Number	Description
1	Revised or Added Plan Sheet Nos. 1-2, 7-9, 12; Amendment EBS Download Required.

MISSISSIPPI DEPARTMENT OF TRANSPORTATION
DISTRICT 3 MATERIALS LAB HVAC AND
LIGHTING REPLACEMENT
DETAILED INDEX

Project Number: BWO-3074-82(004)

WORKING NUMBER
DI-1

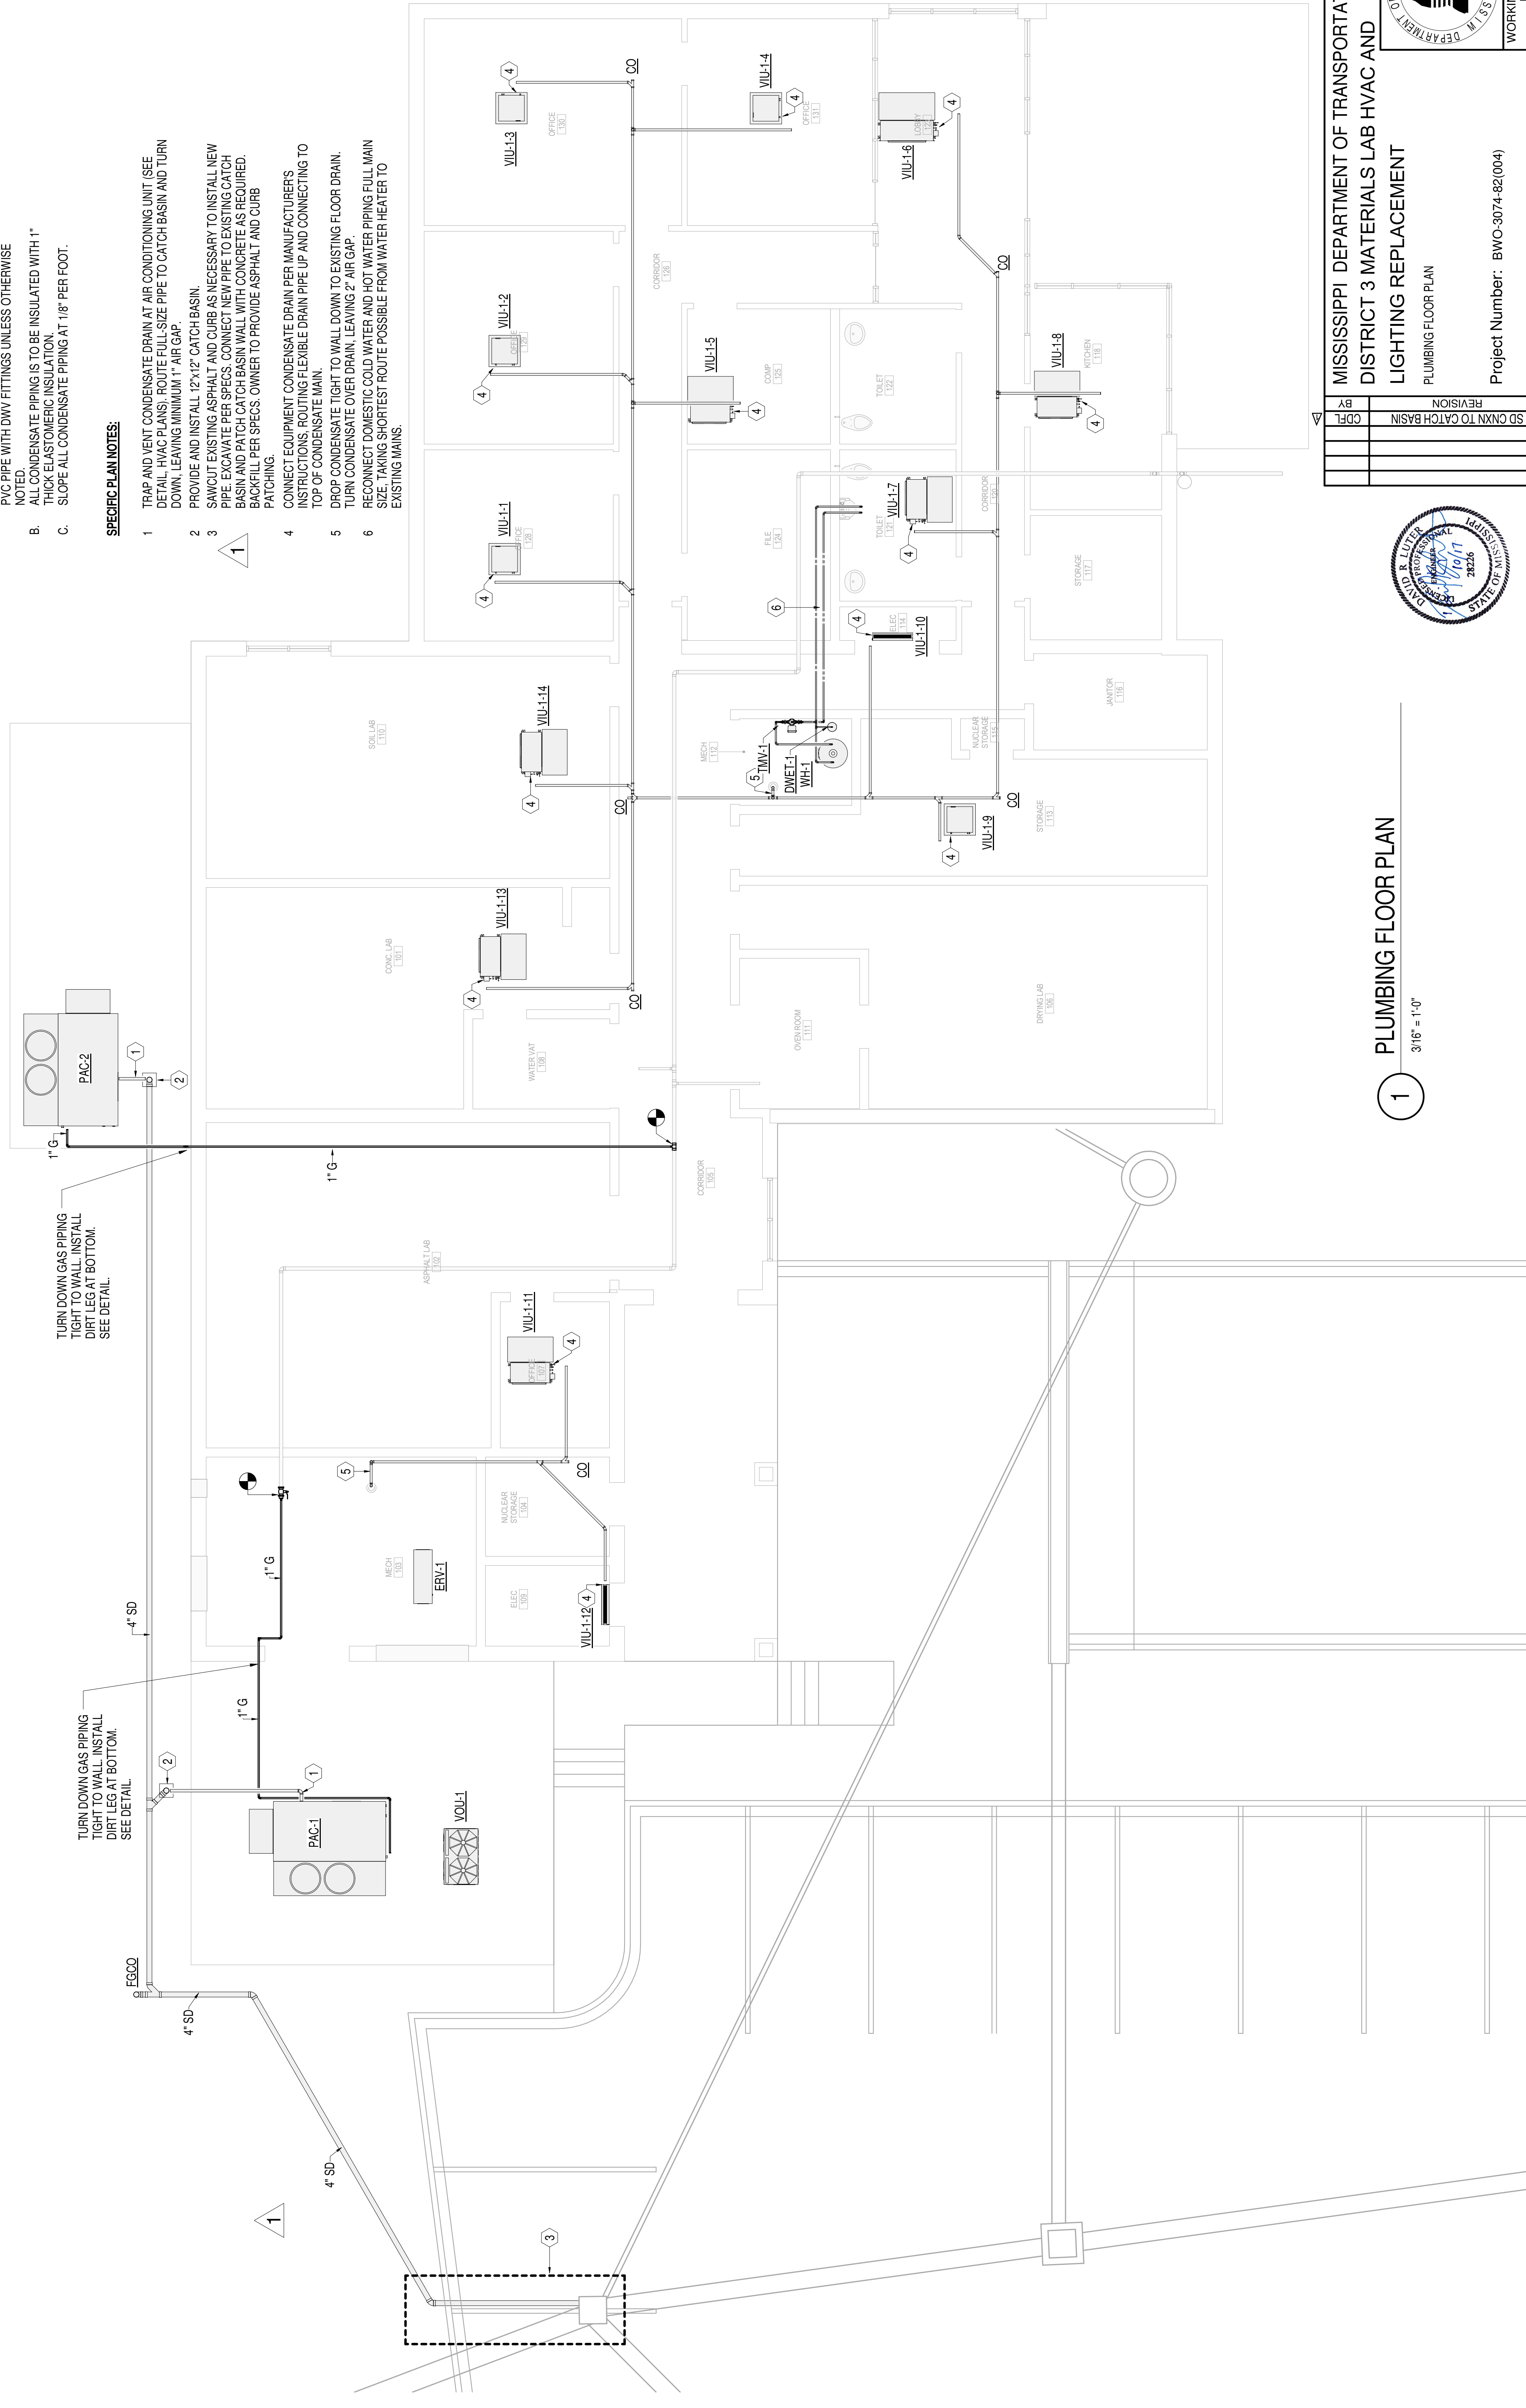
PS & E PLANS - DATE: 10/03/2017	
FMS CON. # 503006 / 301000	
REVISIONS	
DATE	BY
11/01/2017	7, 8
11/15/2017	9, 12
	CDFL
	CDFL

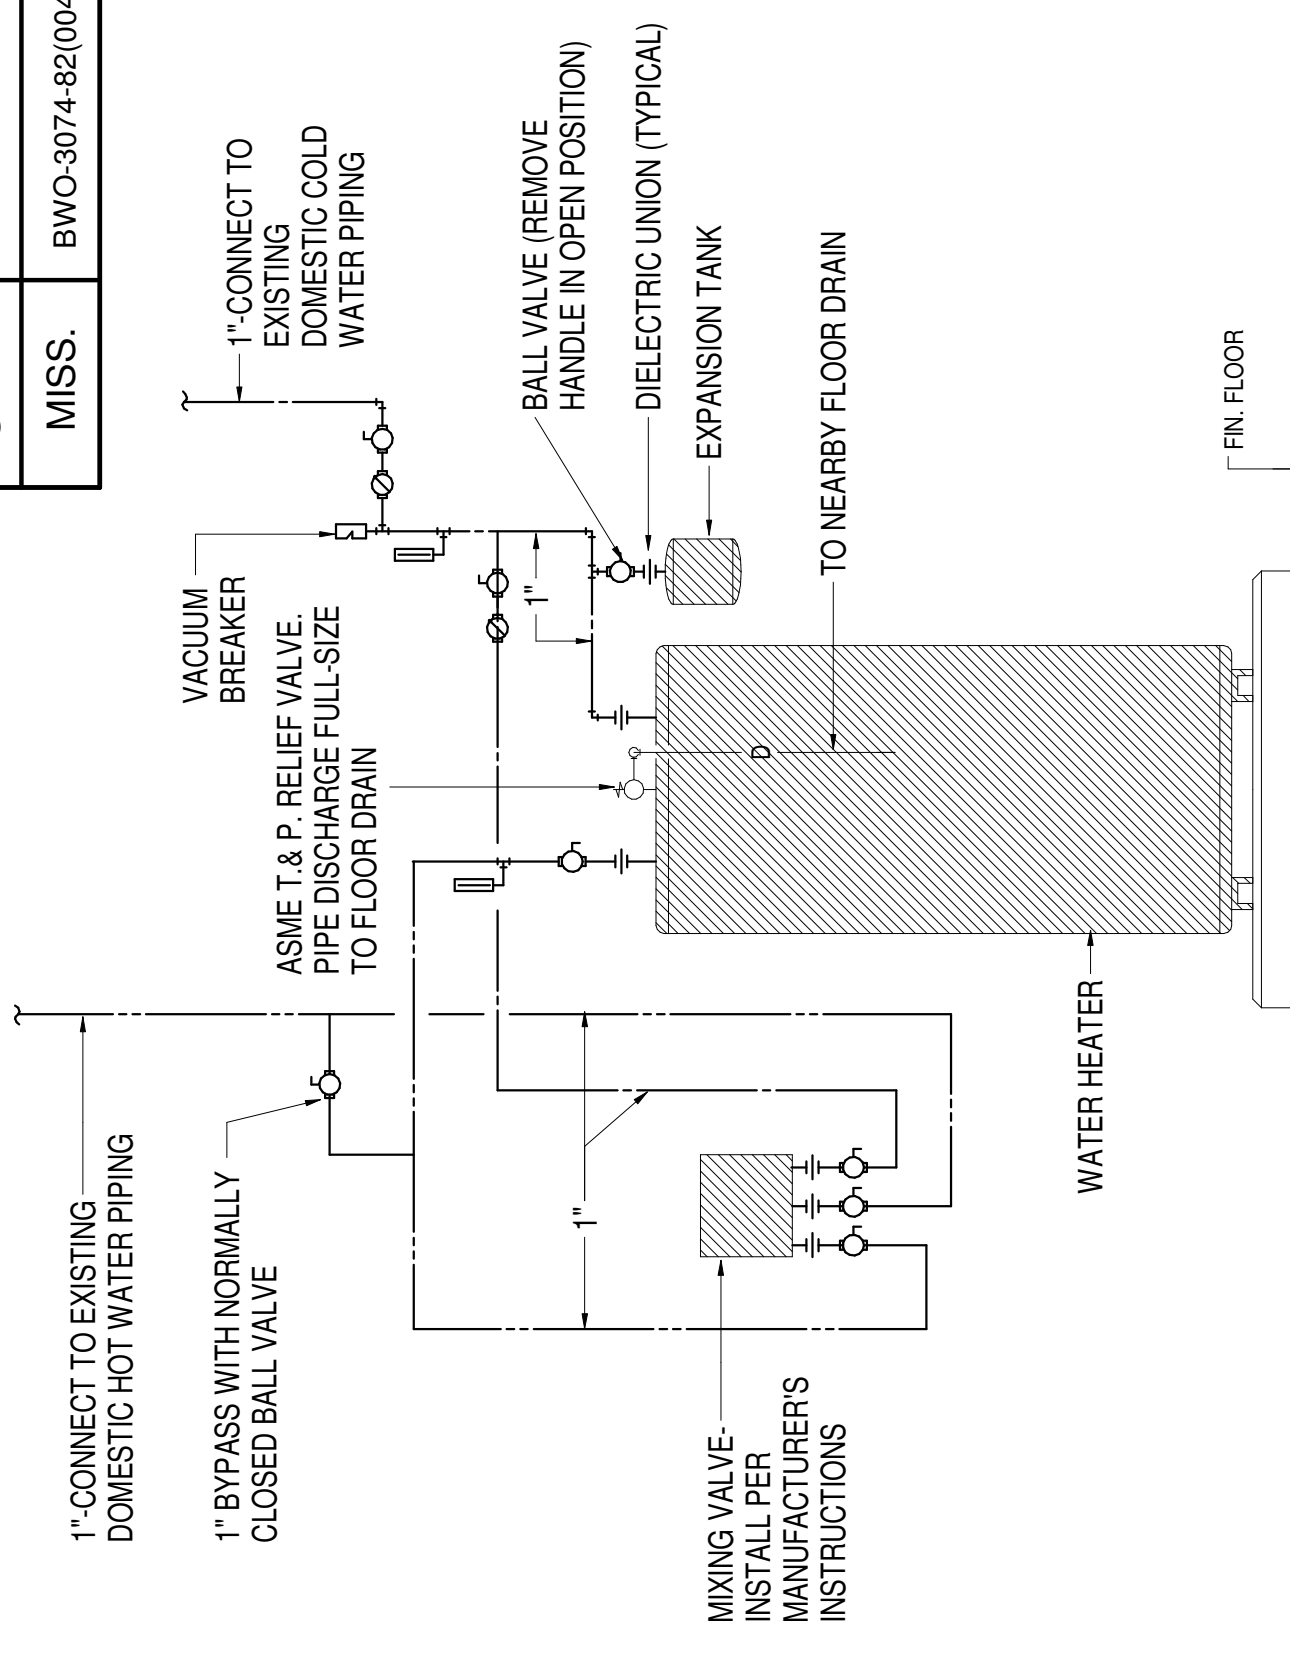
MISSISSIPPI DEPARTMENT OF TRANSPORTATION DISTRICT 3 MATERIALS LAB HVAC AND LIGHTING REPLACEMENT PLUMBING FLOOR PLAN		WORKING NUMBER P-101	SHEET NUMBER 7
Project Number: BWO-3074-82(004)	COUNTY: YAZOO	FILENAME: BWO-3074-82(004)-P-101.dgn	DATE: 11/01/17
DESIGN TEAM: CDFL	CHECKED: DRL	DATE: 10/16/17	
BY: [Blank]	REVISION: [Blank]	DATE: [Blank]	
CDL	SD CNXN TO CATCH BASIN	DATE: [Blank]

- 1 TRAP AND VENT CONDENSATE DRAIN AT AIR CONDITIONING UNIT (SEE DETAIL, HVAC PLANS). ROUTE FULL-SIZE PIPE TO CATCH BASIN AND TURN DOWN, LEAVING MINIMUM 1" AIR GAP.
- 2 PROVIDE AND INSTALL 12"x12" CATCH BASIN.
- 3 SAWCUT EXISTING ASPHALT AND CURB AS NECESSARY TO INSTALL NEW PIPE. EXCAVATE PER SPECS. CONNECT NEW PIPE TO EXISTING CATCH BASIN AND PATCH CATCH BASIN WALL WITH CONCRETE AS REQUIRED. BACKFILL PER SPECS. OWNER TO PROVIDE ASPHALT AND CURB PATCHING.
- 4 CONNECT EQUIPMENT CONDENSATE DRAIN PER MANUFACTURER'S INSTRUCTIONS, ROUTING FLEXIBLE DRAIN PIPE UP AND CONNECTING TO TOP OF CONDENSATE MAIN.
- 5 DROP CONDENSATE TIGHT TO WALL DOWN TO EXISTING FLOOR DRAIN.
- 6 RECONNECT DOMESTIC COLD WATER AND HOT WATER PIPING FULL MAIN SIZE, TAKING SHORTEST ROUTE POSSIBLE FROM WATER HEATER TO EXISTING MAINS.

EXTERIOR FLUSH GRADE CLEANOUT DETAIL
NOT TO SCALE

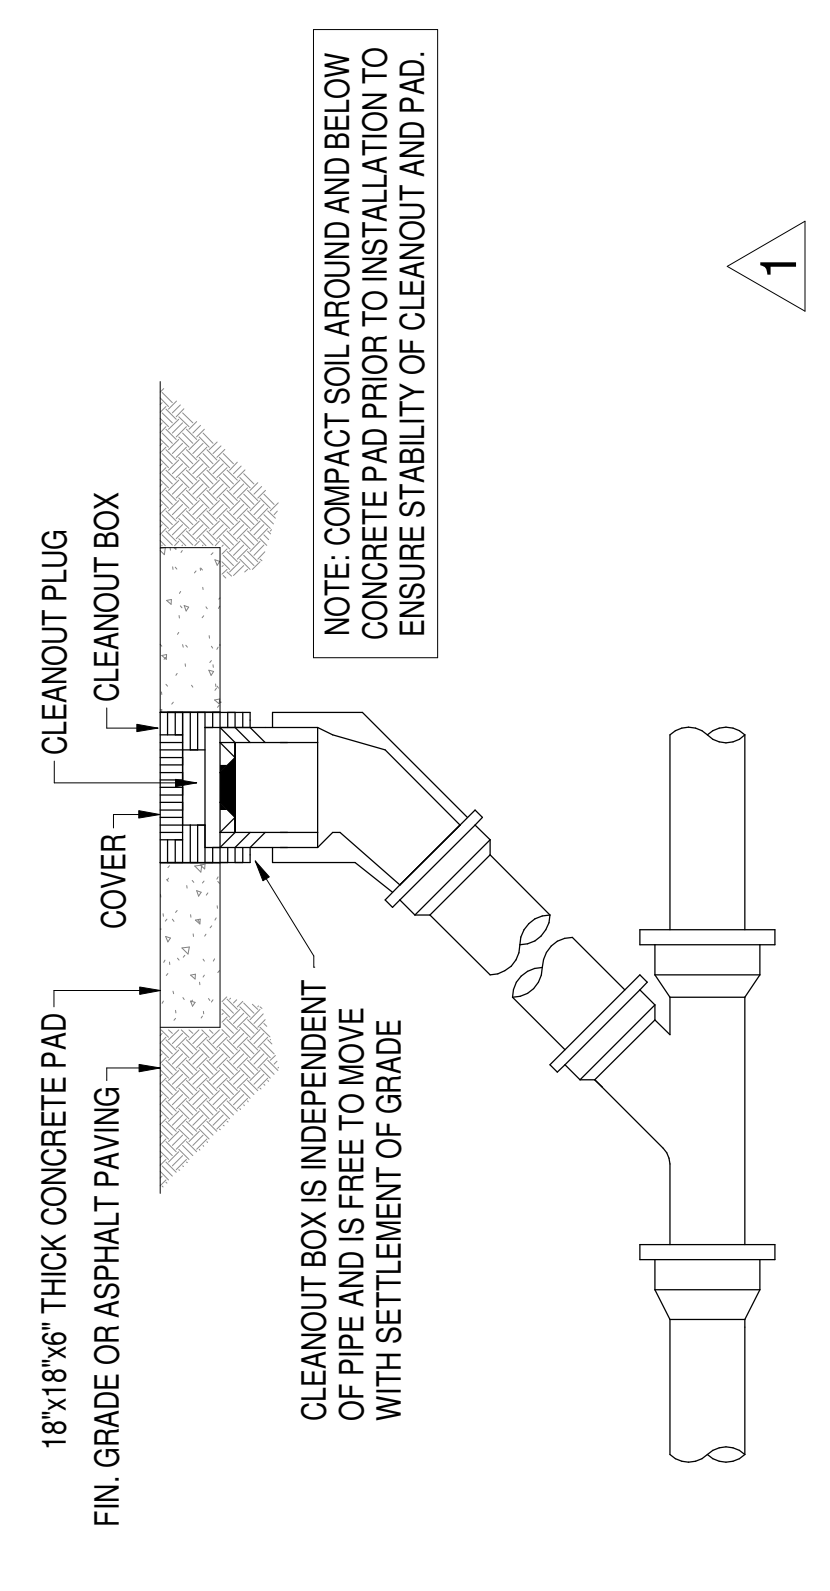
MISSISSIPPI DEPARTMENT OF TRANSPORTATION DISTRICT 3 MATERIALS LAB HVAC AND LIGHTING REPLACEMENT PLUMBING DETAILS		PROJECT NUMBER: BWO-3074-82(004) COUNTY: YAZOO	WORKING NUMBER: P-501 SHEET NUMBER: 8
FILENAME: BWO-3074-82(004)-P-501.dgn	DATE: 10/16/17		
DESIGN TEAM: CDFL	CHECKED: DRL	DATE: 10/16/17	
BY: [Signature]	REVISION:		
CDL	ADDED FGCO DETAIL
